17-097MSP – PENZONE SALON

Request

Approval of a Master Sign Plan (MSP) for the 12,000-square-foot Charles Penzone Grand Salon and existing salon on a 1.8-acre parcel.

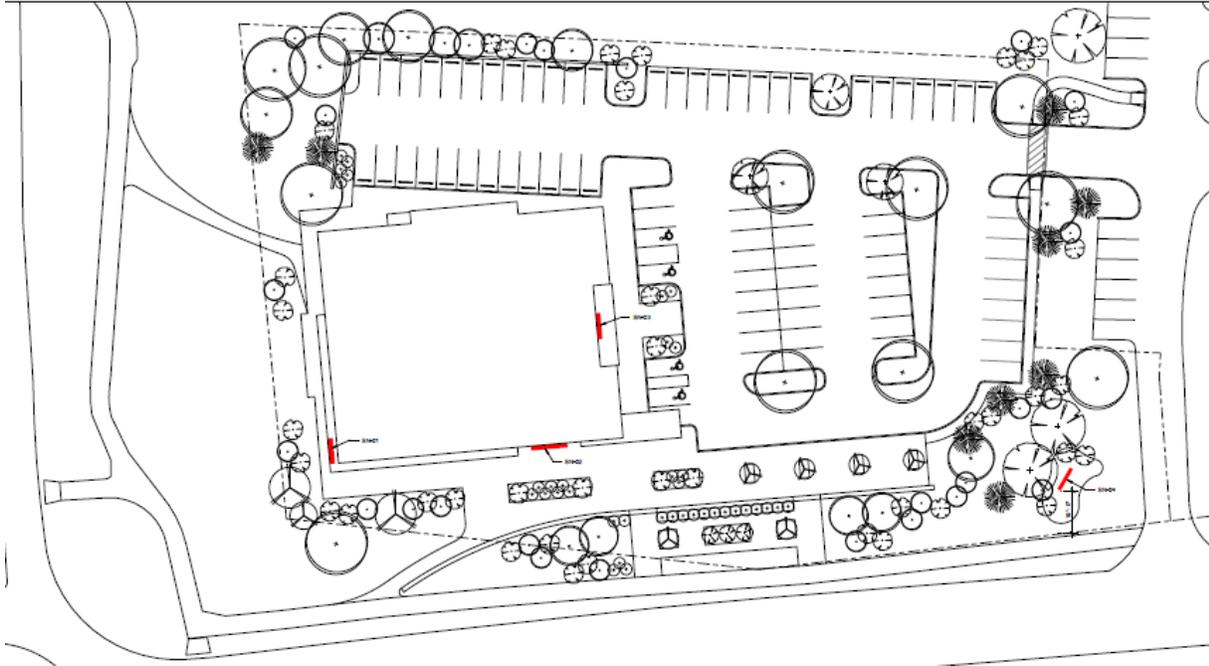
The applicant is proposing two new wall signs on the north and east elevations. The proposed sign on the north which faces the parking lot is proposed as a ±34-square-foot internally illuminated sign with individual white channel letters and black returns at a height of 16'6" from grade to the top of the sign. As proposed this sign meets the BSD Code requirements which permits a 50-square-foot sign located within the first story of the building.

The second wall sign on the east elevation is proposed as a ±66-square-foot sign with channel-cut, back lit letters mounted on a 230-square-foot black metal panel cabinet which is lit around the edges. The letters are mounted 12-feet from grade within the panel. The metal cabinet is 14'4" from grade to top of cabinet. The metal cabinet will conceal gas meter mechanical equipment and the illumination light source equipment. A hinged access for the gas meter is located at the lower right corner of the cabinet and is approximately 37 square feet in size and designed of the same material.
